CITY OF SOMERVILLE, MASSACHUSETTS
OFFICE OF STRATEGIC PLANNING & COMMUNITY DEVELOPMENT
JOSEPH A. CURTATONE
MAYOR

HISTORIC PRESERVATION COMMISSION

ALTERATION TO A HISTORIC PROPERTY STAFF REPORT

Site: 1 Westwood Road c.1929 Somerville Museum
Case: HPC 2015.073 Westwood Road Local Historic District

Main entry to 1 Westwood Road, 2011

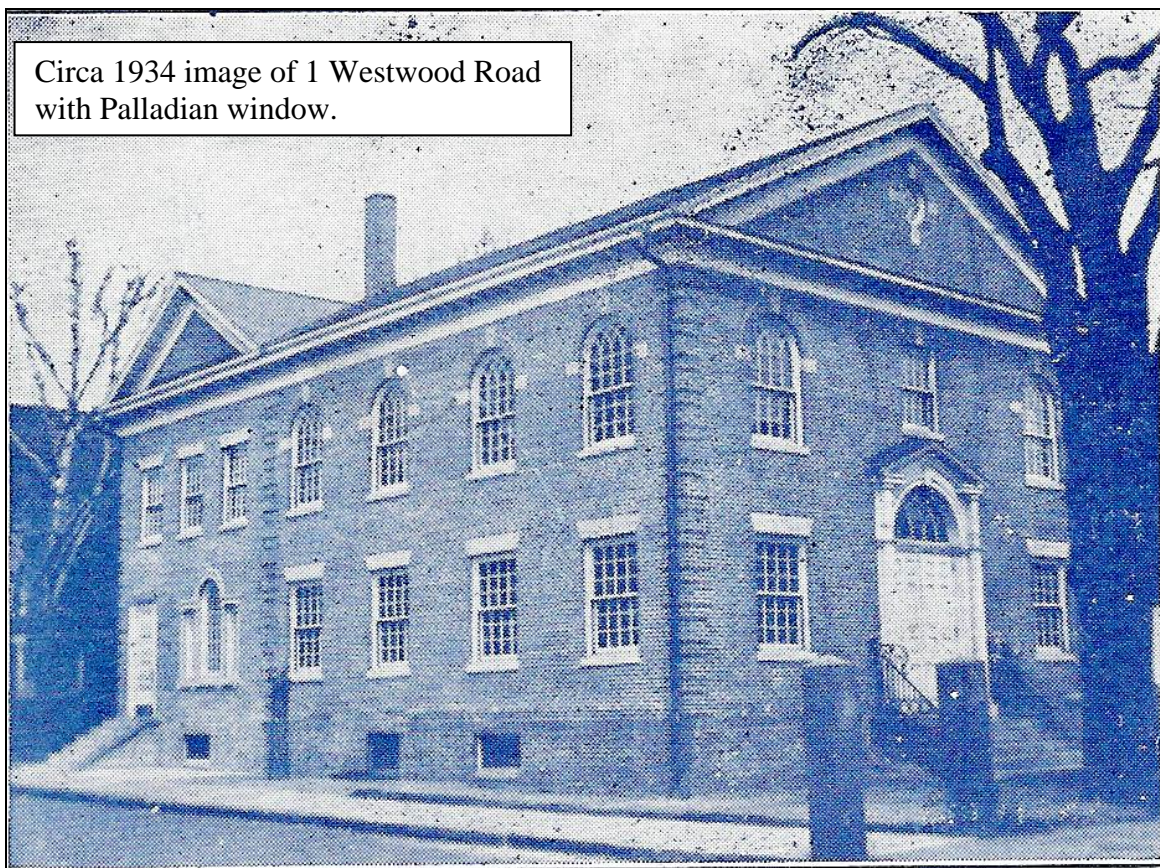
The proposal is more appropriate than the existing 1980s era steps and entry. At a meeting with Staff and an Architect from the Commission on February 4, 2016, a new design was reviewed and refinements made. The design, based upon a Colonial era building in Saugus with similar proportions, lends itself to the purposes of the Museum and compliments the original building.

The addition was not discussed in the Form B. Material will be removed from the building to accommodate the new addition with the LULA. The existing Westwood Road entry was constructed circa 1980 and is not original to the building. There will be no replacement of materials although the Palladian window stored since 1986 will be reinstalled somewhere on the building per MHC Preservation Restriction at a later date. The new materials will be traditional. These consist of brick, cast stone, glass, wood clapboard, casings and other trim elements. There is no clapboard on the brick building currently and will help to serve to differentiate the old from the new. The addition is visible from the right of way.

1. All appropriate building permits shall be obtained prior to the start of any work.
2. If the approval differs from the plans, new plans shall be submitted to Historic Staff prior to commencing the work;
3. The Westwood Road entry porch and stairs shall be demolished.
4. An approximately 6'3" by 22'3" addition with new entries and elevator shall be constructed as per plans by Peter Quinn Architects dated February 10, 2016.
